Technical Note

201-27 (202, 203, 204)
205-17, 206-14
301-34, 303-15, 304-5
401-21, Falcon Nr.2

Subject: Elevator actuating bracket

201-33-4

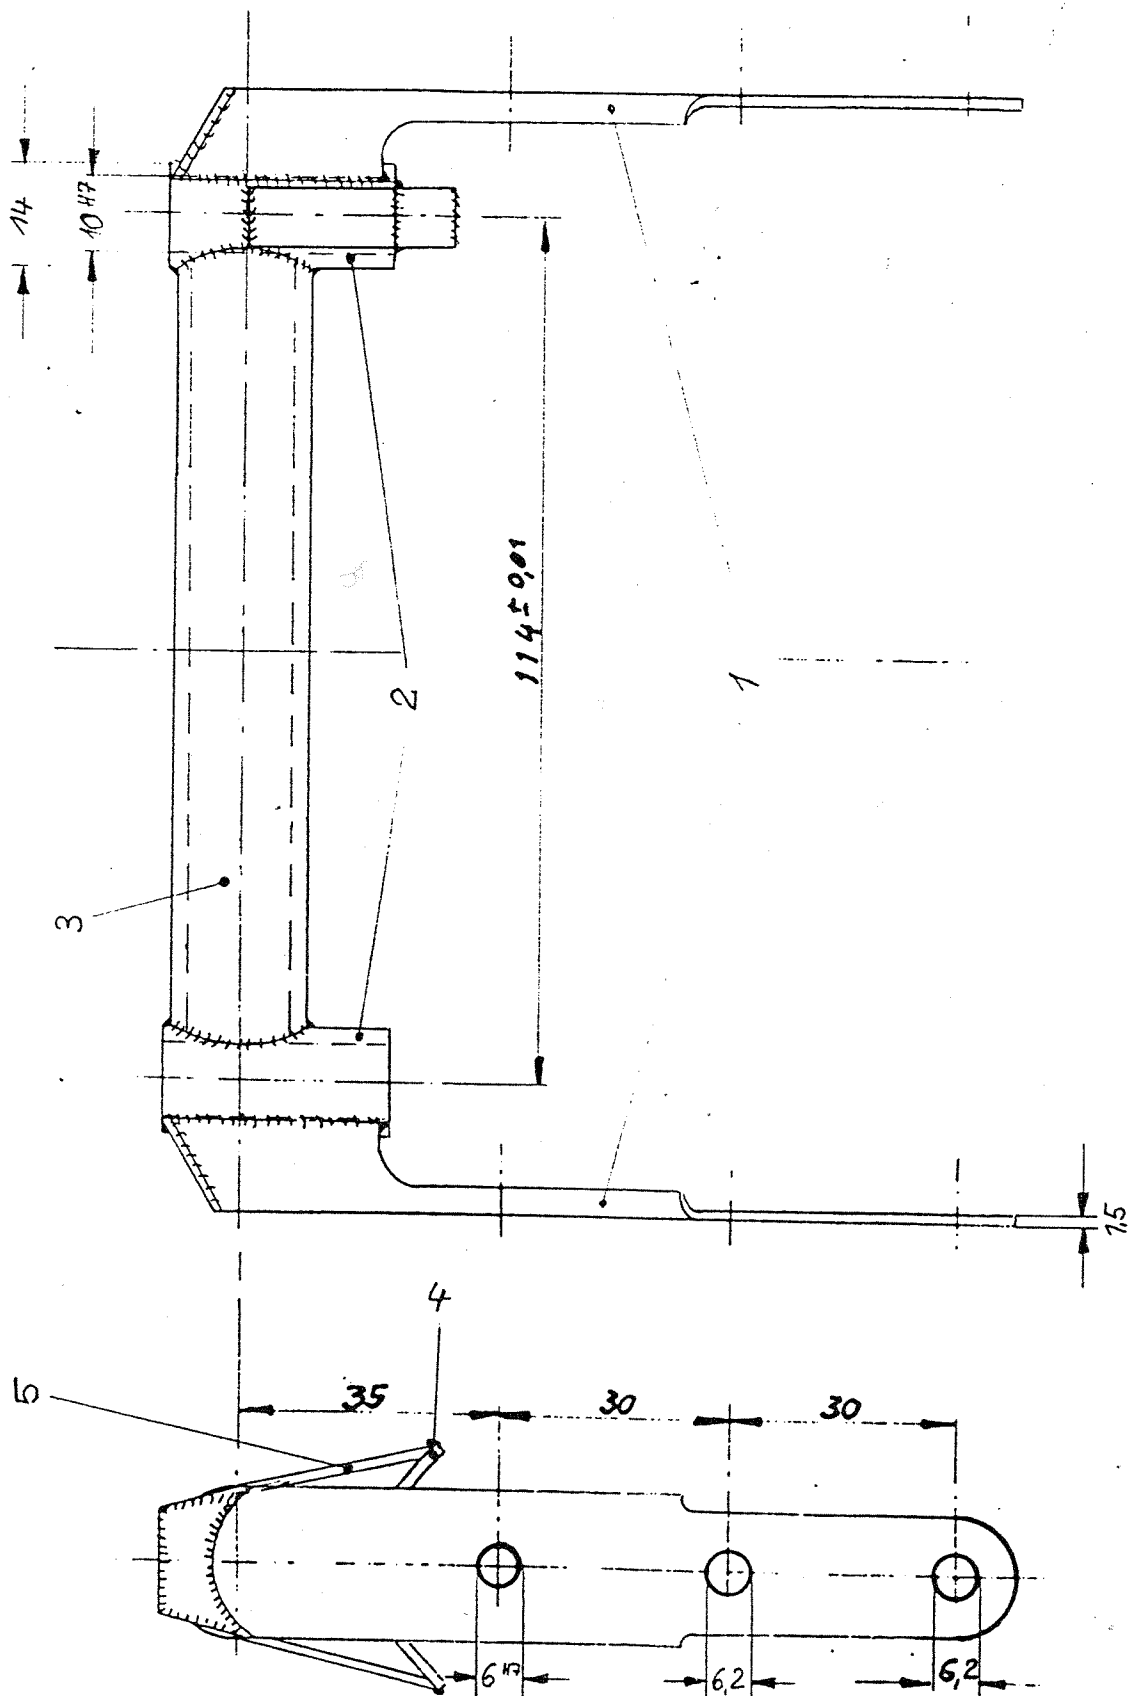
Reason: Use of a bracket as per drawing no. 201-33-4 instead of former bracket types permissible.

Actions: In case of elevator actuating exchange use following procedure:
Unscrew the 6 screws on the elevator actuating bracket. Pay attention to the type and number
of washers at each bolt. Mark position precisely!
Install new actuating bracket including the washers on the same position.
Tighten screws carefully and check free motion of the elevator.
